**NOTICE OF A REGULAR MEETING
BONDURANT PLANNING AND ZONING COMMISSION
JULY 22, 2021**

6. Action Items
 - a. RESOLUTION NO. PZ-210722-15: Considering recommended approval of the Black Oak Farm Plat 1 Preliminary Plat (Unincorporated Polk County)

- c. RESOLUTION NO. PZ-210722-17: Considering recommended approval of the Dollar General site plan at 501 Hawthorne Crossing Drive SE.
 - d. PUBLIC HEARING - Request for rezoning from the Agricultural (A-1) District to the Planned Unit Development (R-5) District on property currently owned by Top Farms LLLP north of Park Side Plat 2 and adjacent to Highway 65; and request for Future Land Use Map amendment from Single-Family Residential to Multi-Family and Commercial on areas as shown on the PUD Conceptual Plan.

- f. RESOLUTION NO. PZ-210722-19: Considering recommended approval of the RAMMS Construction site plan at 1120 2nd Street NE.
7. Reports / Comments and appropriate action thereon:

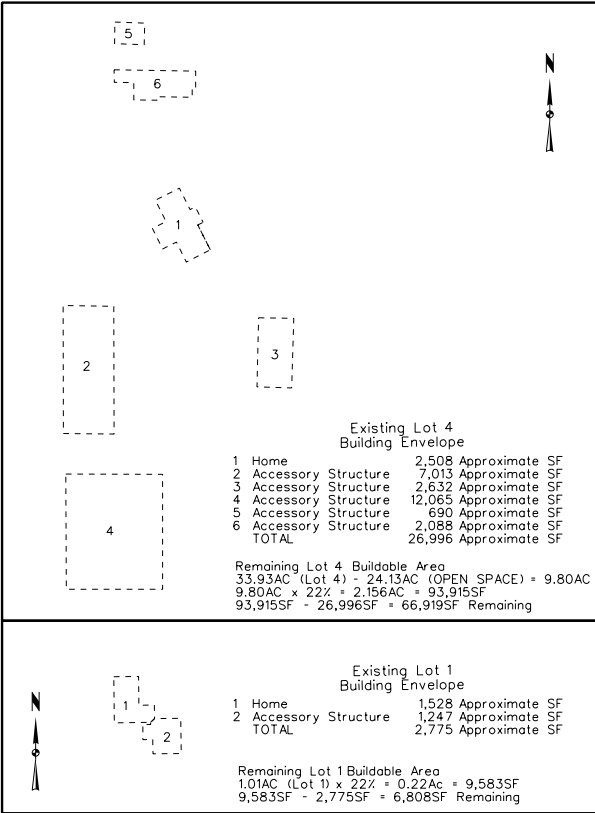
1. The City of Bondurant's Streets Master Plan would suggest a right-of-way wider than 66' along NE 88th Street. The area south of this plat on the east side of NE 88th Street shows half the right-of-way as being 40' wide. The preliminary plat should be updated to show a minimum 40'-wide half right-of-way along NE 88th Street.

1. That the preliminary plat shall be updated to show a minimum 40'-wide half right-of-way along NE 88th Street.
2. That approval of the preliminary plat includes waiver of Section 180.05.2 of the Subdivision Code relative to maximum block length requirements along NE 100th Avenue.

SHEET
C6

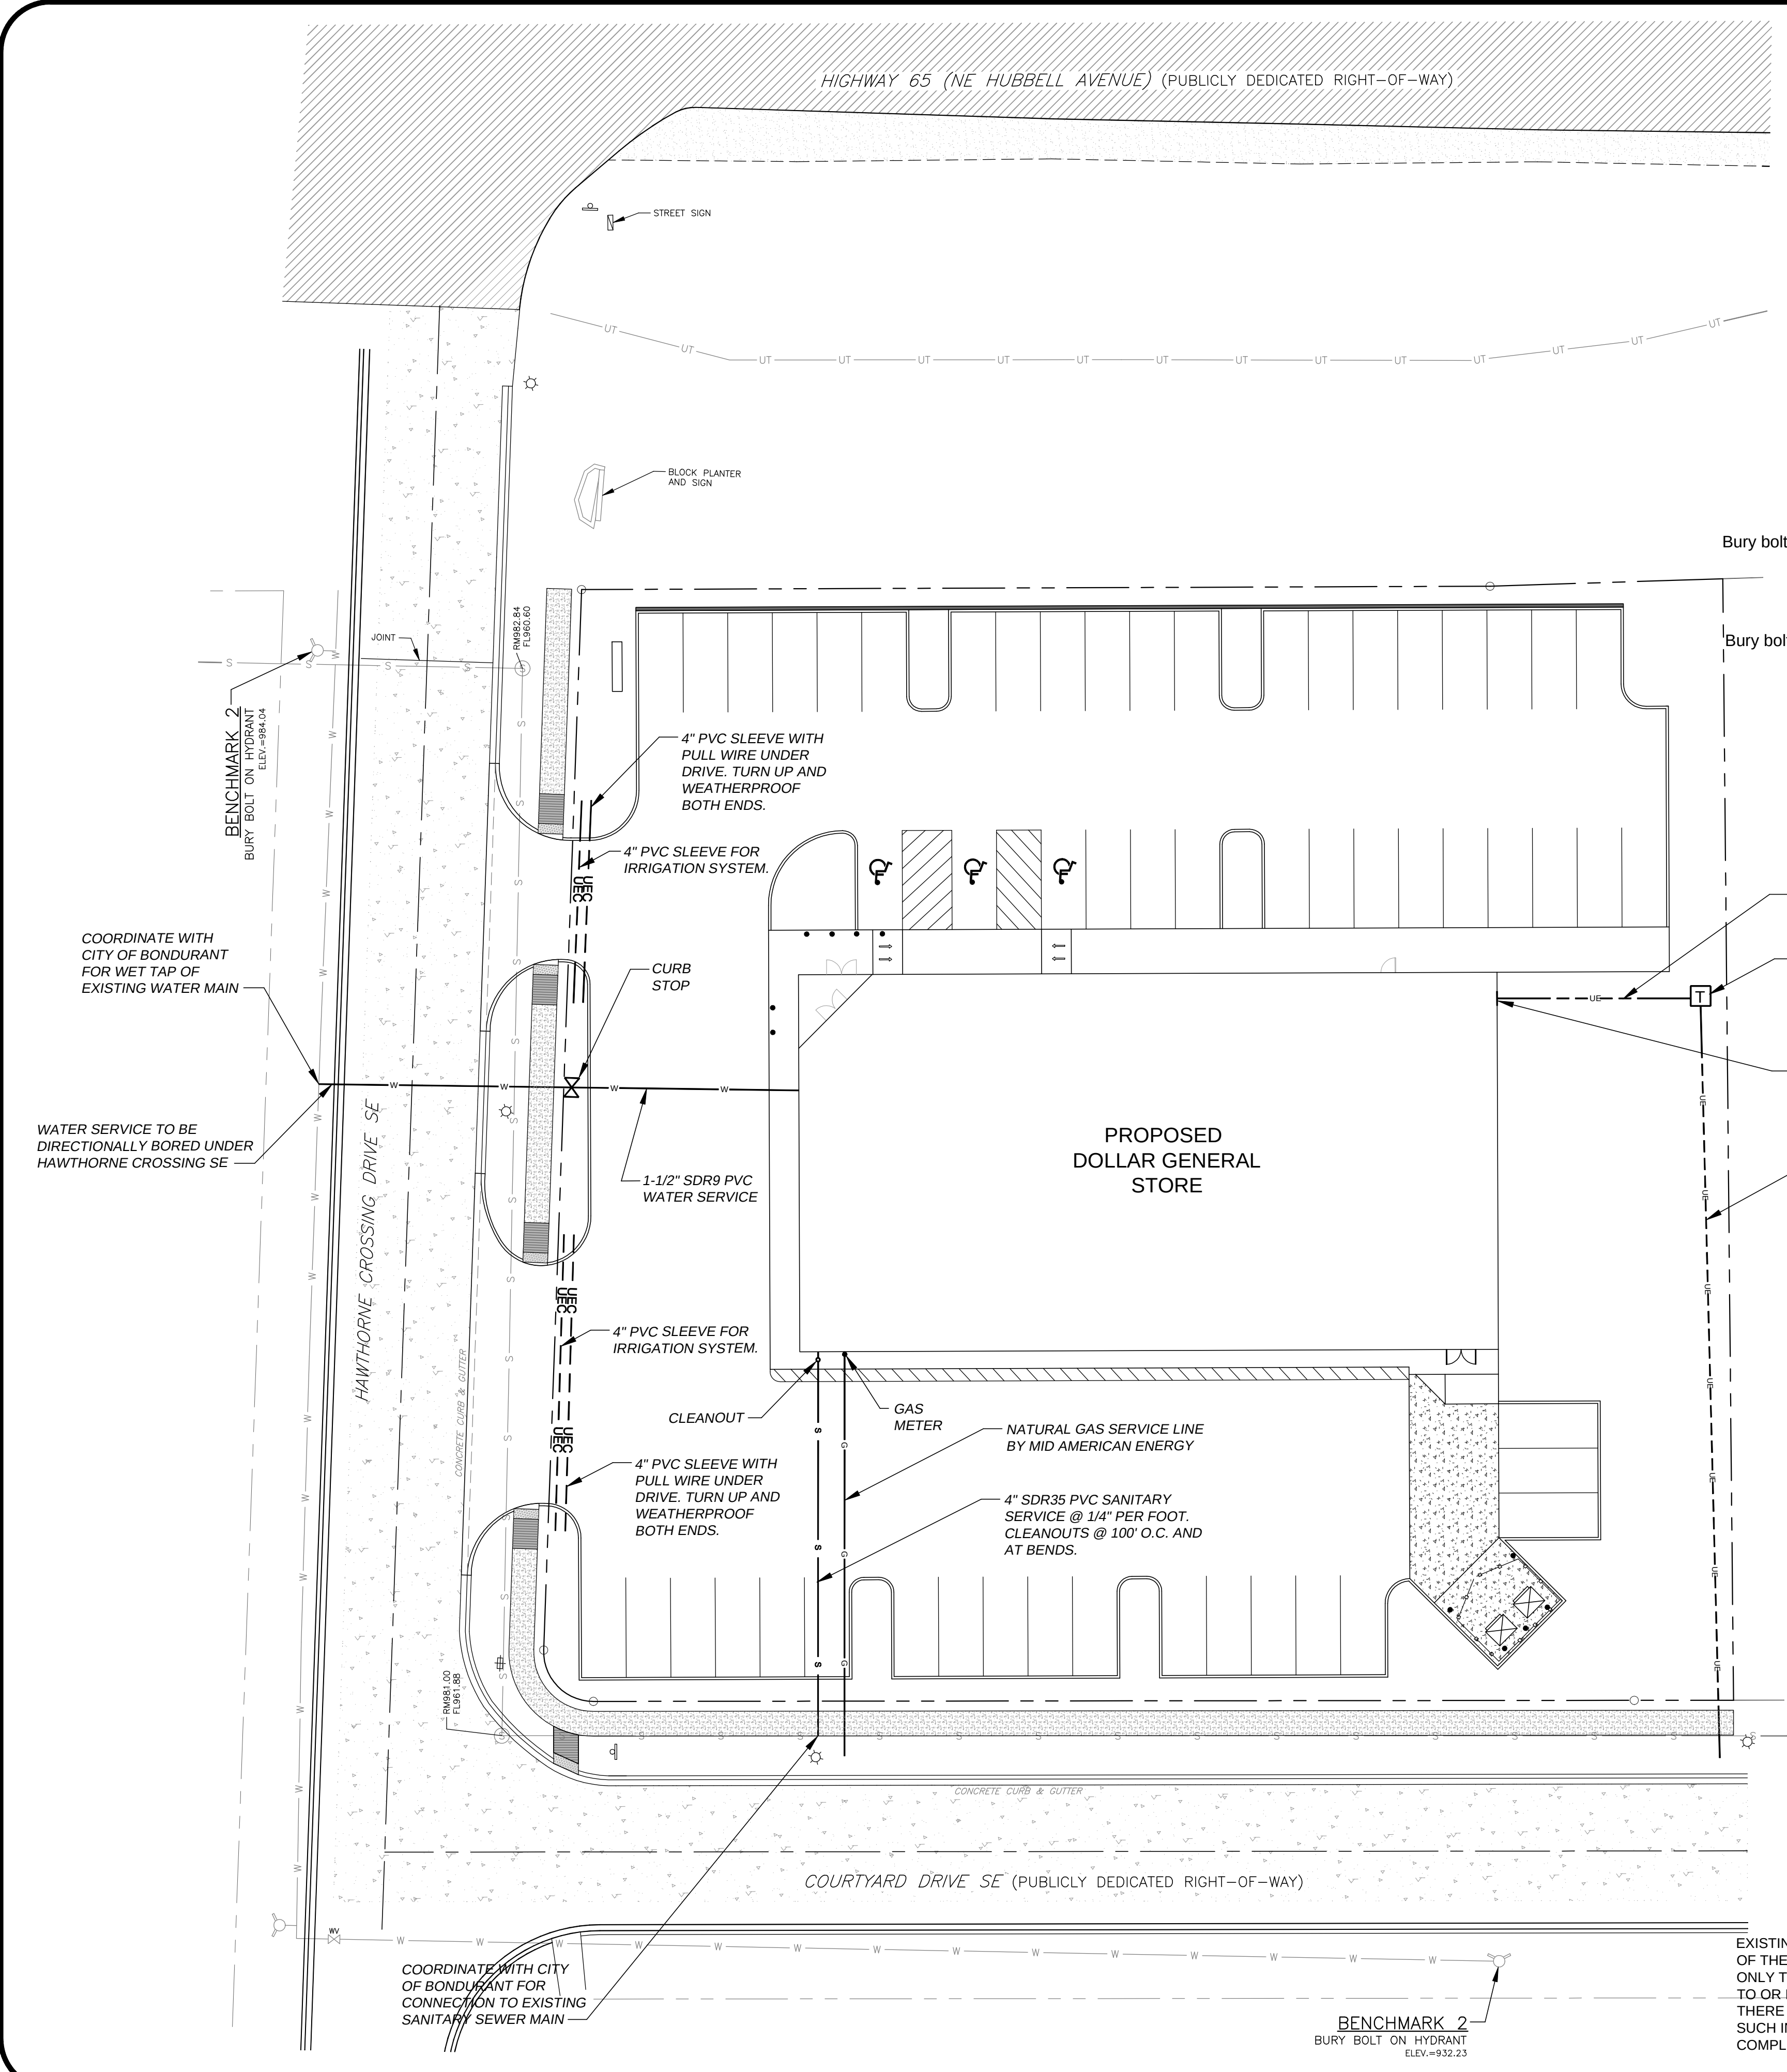
- Page C6 contains the required landscaping plan. Notes on this:
 - This site has 690' of street frontage. $690'/50 =$ at least 14 general trees required. The landscaping plan shows 14 general trees are proposed. The landscaping plan shows that these 14 general trees will be planted within the required 30' front yard setback area, which meets Section 182.05.E of the Zoning Code. The landscaping plan also shows that all trees will be planted at least 4' away from front property lines, as is required by Section 182.05.E.

- This site must have have 54 parking spaces. $54/18 =$ at least 3 interior trees required. The landscaping plan shows 3 interior trees proposed.
 - The landscaping plan notes that all trees (general and interior) will be deciduous shade. Section 182.05.D.1 of the Zoning Code notes that all trees on site may be deciduous shade.

- The landscaping plan notes that the deciduous shade trees will be a minimum of 1 3/4 inch caliper in size at time of planting, as is required by Section 182.04 of the Zoning Code.

- The site plan shows that 5% of the parking lot area will be interior greenspace, which meets the minimum % requirement of Section 177.10.7.A.

SITE UTILITY PLAN

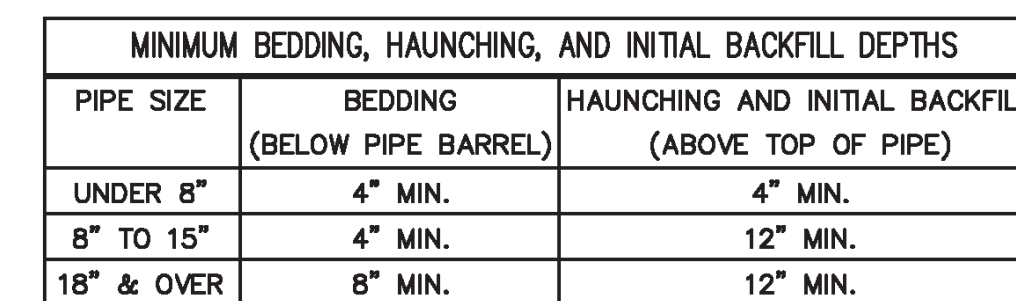
- Page C8 contains the required utility plan. This page shows that the building's sanitary sewer service will connect to the existing sanitary sewer main along Courtyard Drive SE. The building's water service will connect to the existing water main located on Hawthorne Crossing Drive SE.

PUD CONCEPTUAL PLAN

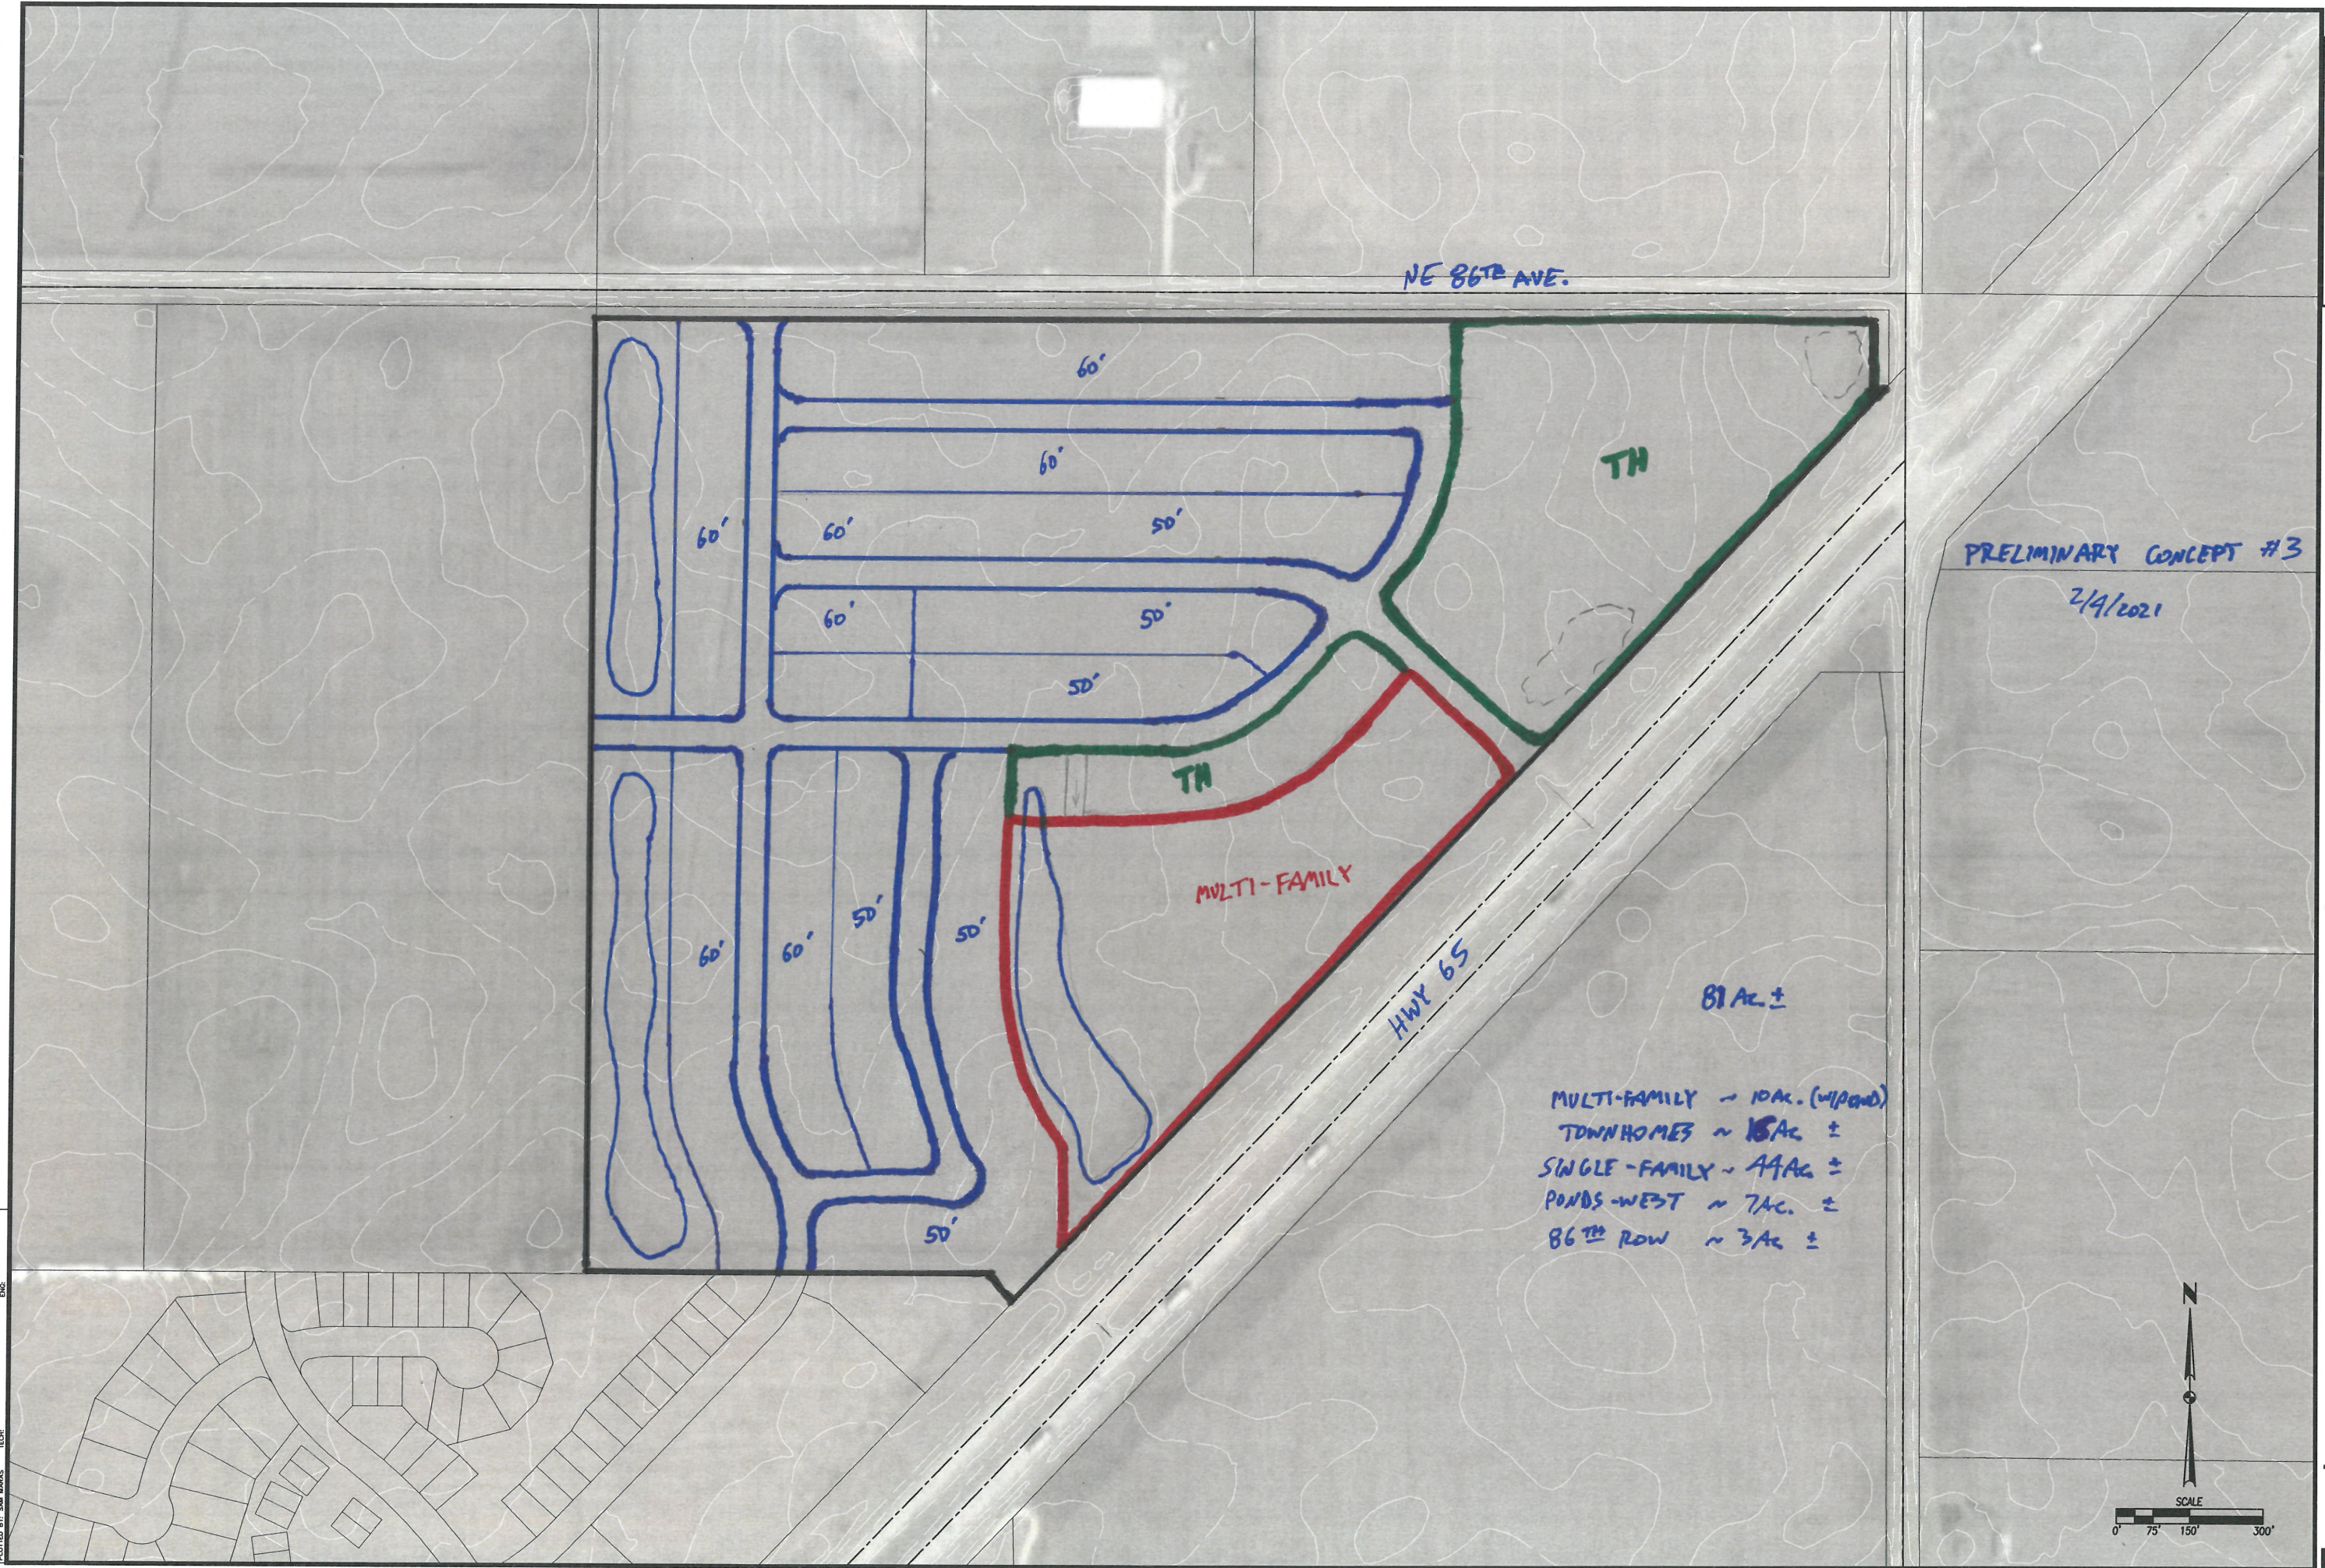
Parkland. The Conceptual Plan must be updated to show and clearly note that public parkland dedication shall comply with Section 180.06 of the Subdivision Code. Below are some summary notes on this topic but not Section 180.06 in its entirety:

- The Conceptual Plan appears to show three stormwater detention pond areas. It is the City's practice to require that detention ponds be privately owned and maintained and not publicly owned and maintained.

- The 2013 Park, Trail & Greenway Master Plan identifies a need for a neighborhood park in this Top Farms LLLP area.
- If proposing public parkland,
 - Per Section 180.06.6, at a minimum 75% of the area to be dedicated shall be capable of development as active recreation area as determined by it being sufficiently level and uninterrupted by public or private utilities, streams, and drainage ditches.

1. Are the Area A lot width and bulk regulations as proposed on the Conceptual Plan considered acceptable by the Commission?
2. Conceptual Plan to be updated to show a front yard setback for the lots having a north property line of NE 86th Street, as is required by Section 177.07.2 of the Zoning Code.
